Westinghouse Response to NRC Observation 3-3 (Non-Proprietary)

OBS 3-3

Demonstrate with supporting analyses and discussion that the thermal models discussed in the thermal chapter accurately model the thermal-related phenomena for steady-state storage and transient operations.

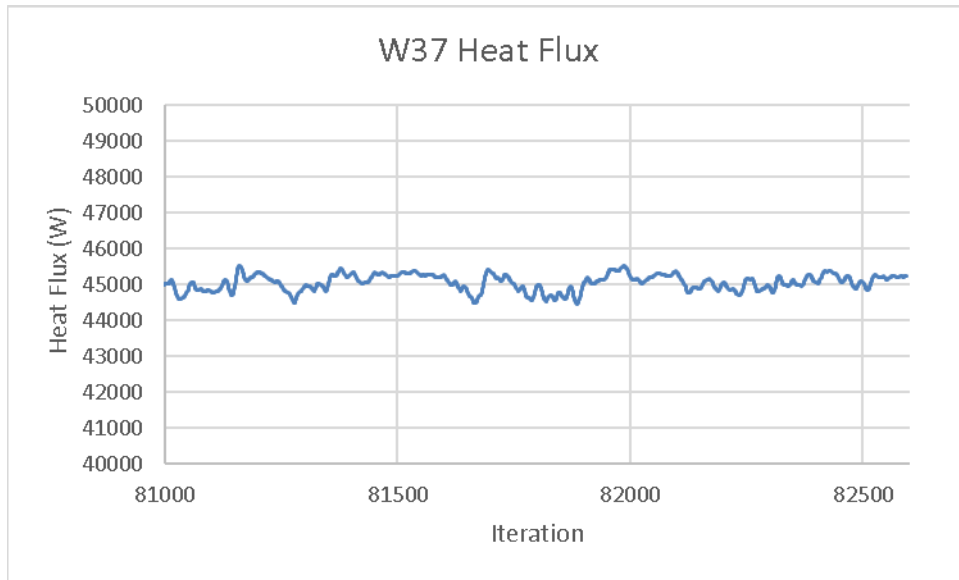
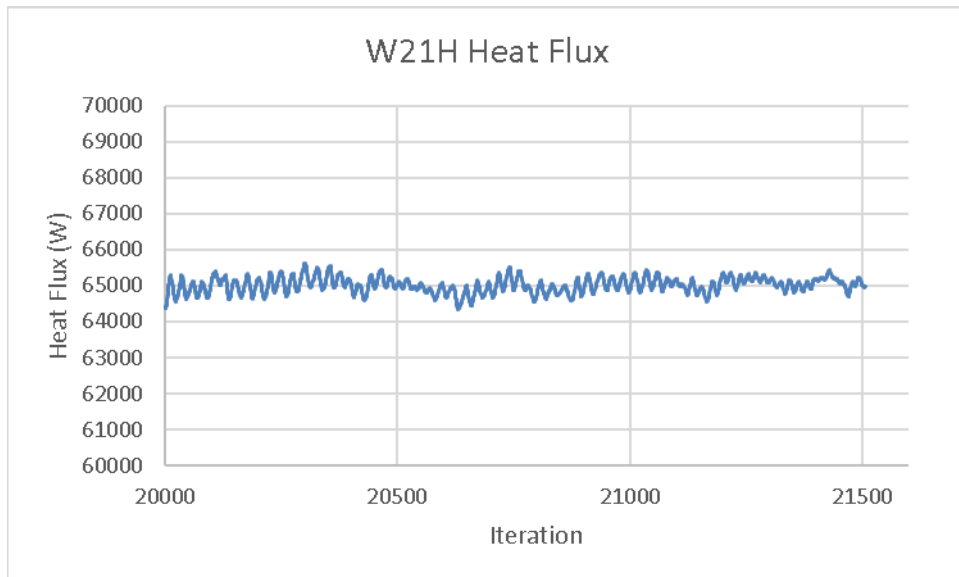
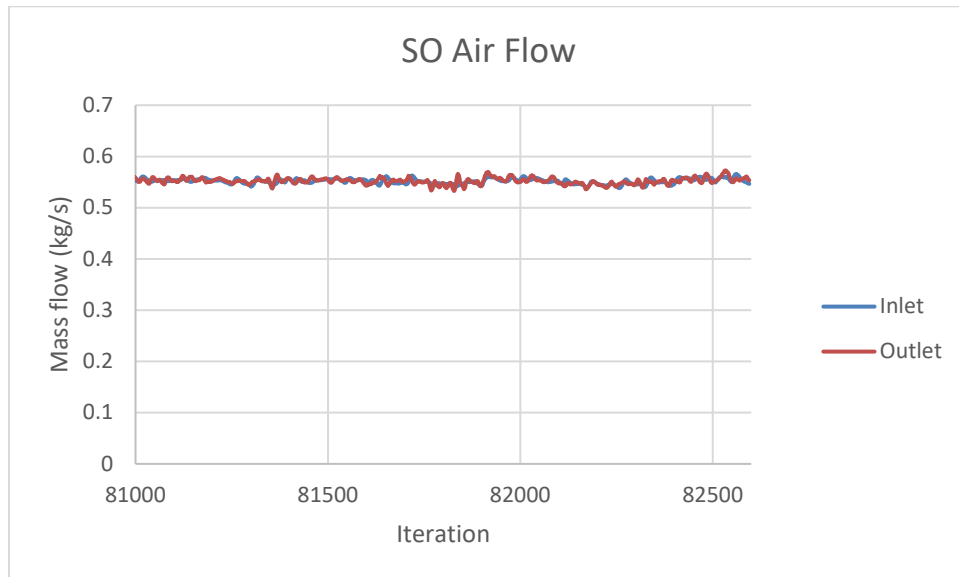
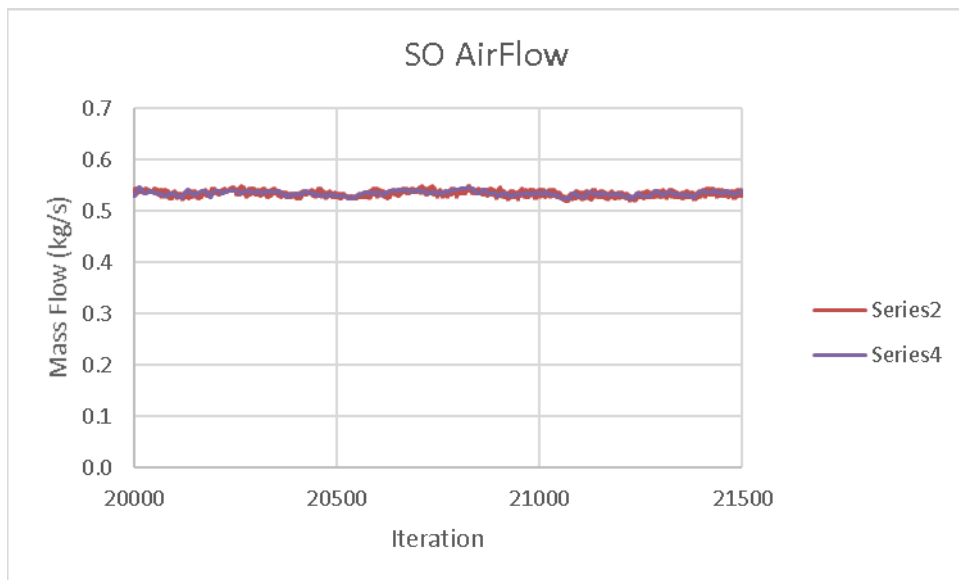
- a. It is noted in the thermal analysis that the PCT results for canister W37 (45 kW) and canister W21H (65 kW) were at similar temperatures. The chapter does not demonstrate how the unique thermal aspects associated with the W21H canister, with much greater power density (kW/m³), would have resulted in a similar PCT as the lower power density canister, nor does it provide input, convergence, energy balances, and solution values to confirm performance of the two canister models.

Other parameters of interest that were checked for convergence are the external heat flux in the outer part of the W180 storage cask (Figure 23 using the W37 canister and Figure 24 using the W21H canister), the cell helium flows (Figure 25 and Figure 26), and the storage cask air flow (Figure 27 and Figure 28).

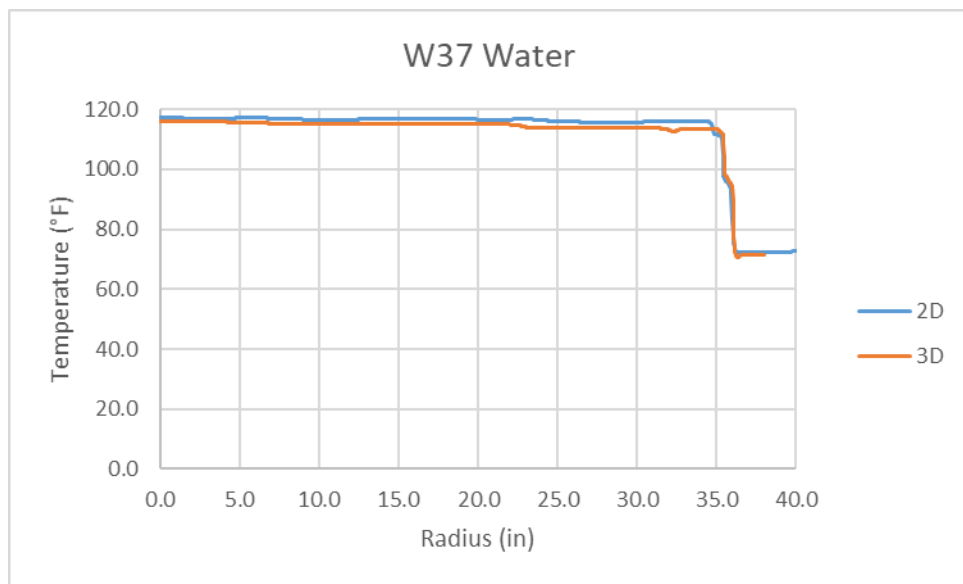
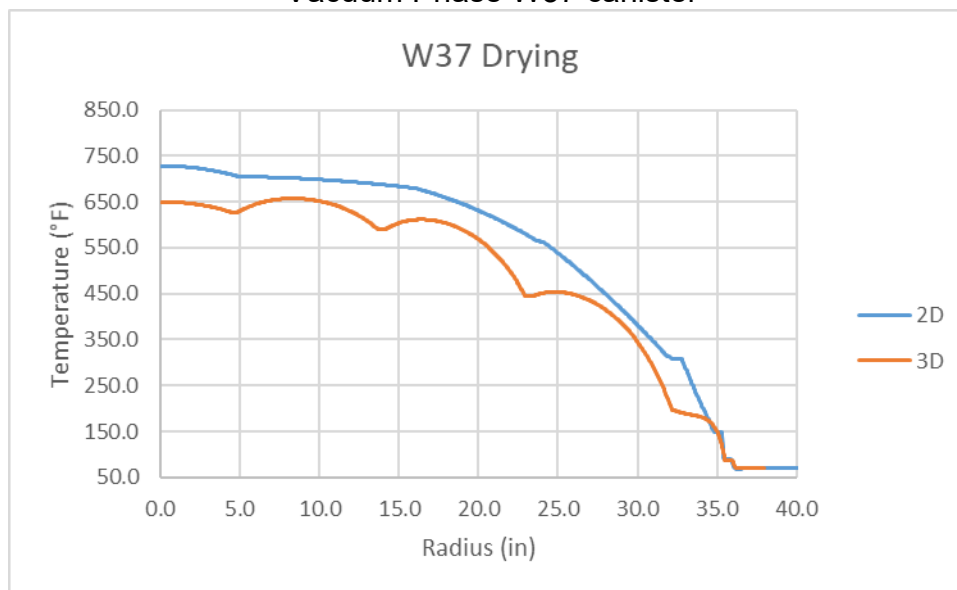
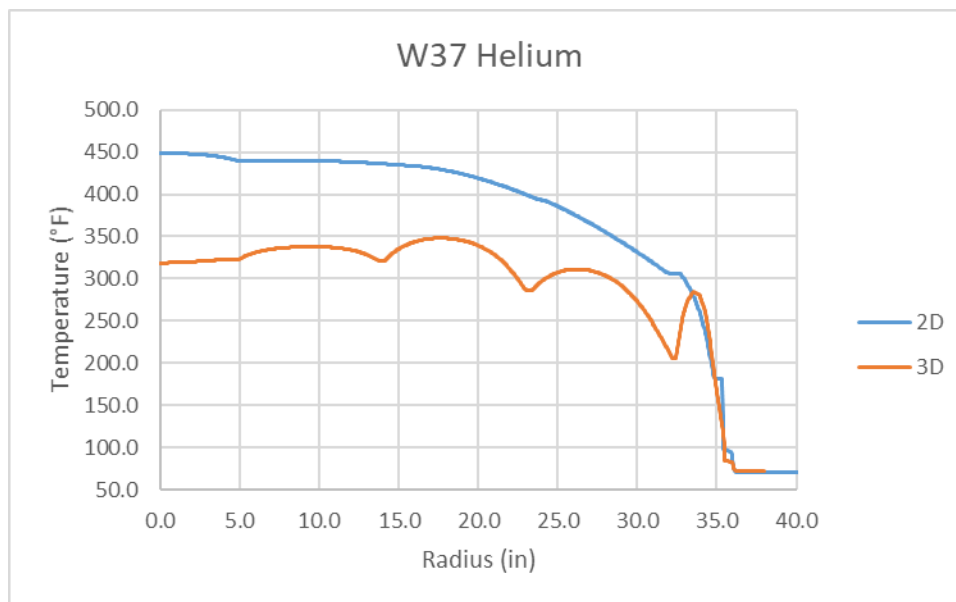
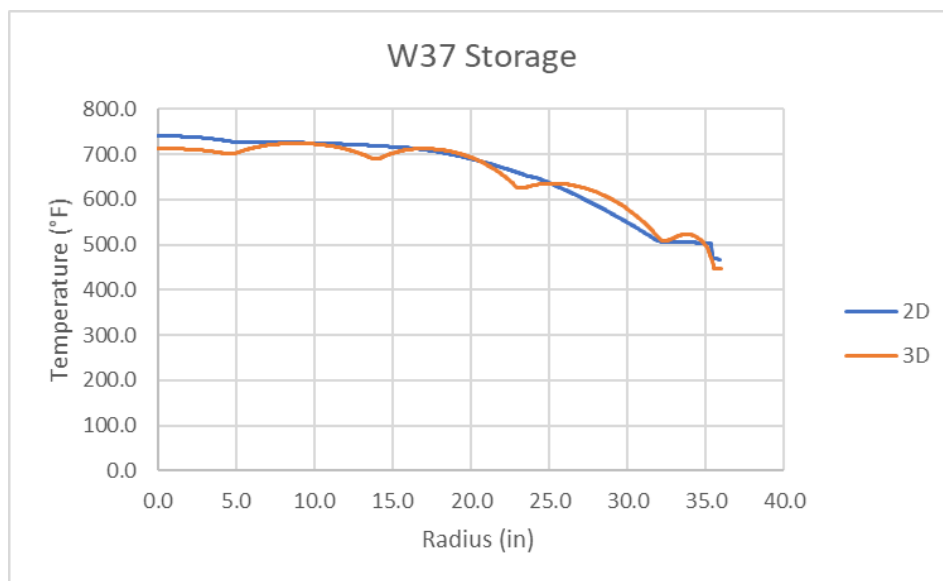
- b. There was limited information and validation associated with the “equivalence” between the (transient) two-dimensional and three-dimensional thermal models, recognizing that a steady-state comparison between 2D and 3D models would not explicitly demonstrate appropriate consideration of thermal mass effects. Using appropriate models are needed to ensure bounding temperatures on important to safety components during steady-state and transient operations.

- b) The validation and conservatisms of the two-dimensional models used to perform the loading operations analyses and fire and total blockage cases of accident analyses are shown in Chapter 5, Section 5A.2. [
